SECTION A-A

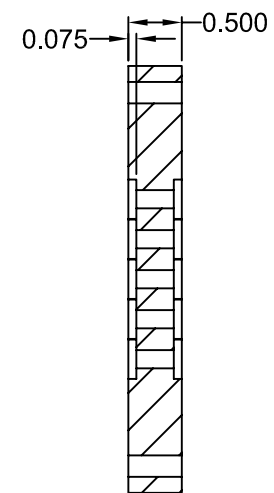
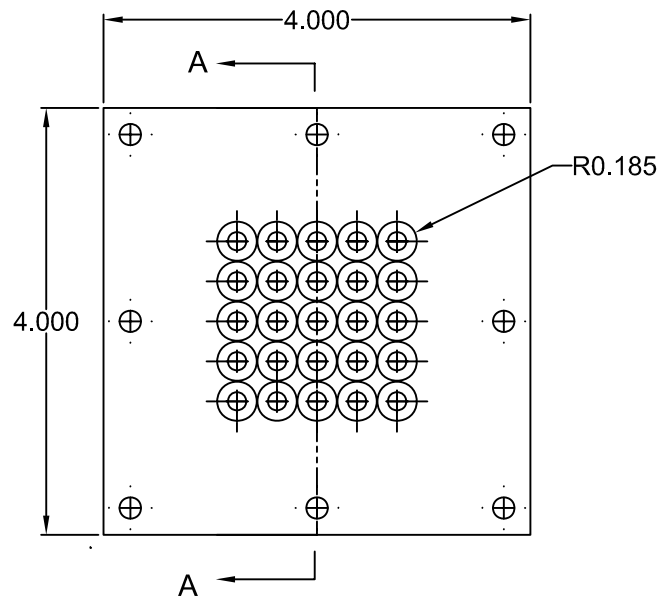
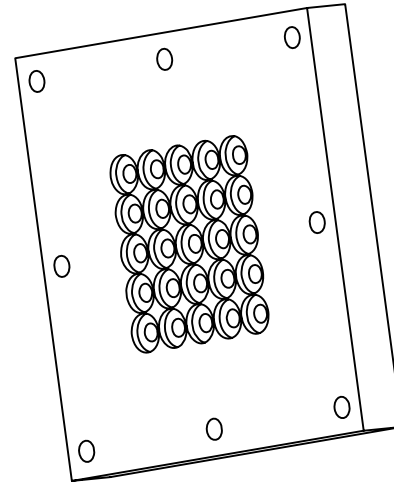
Counter sunk holes for seating
2.4mm x 4.3mm o-ring in place
of previous tapered hole
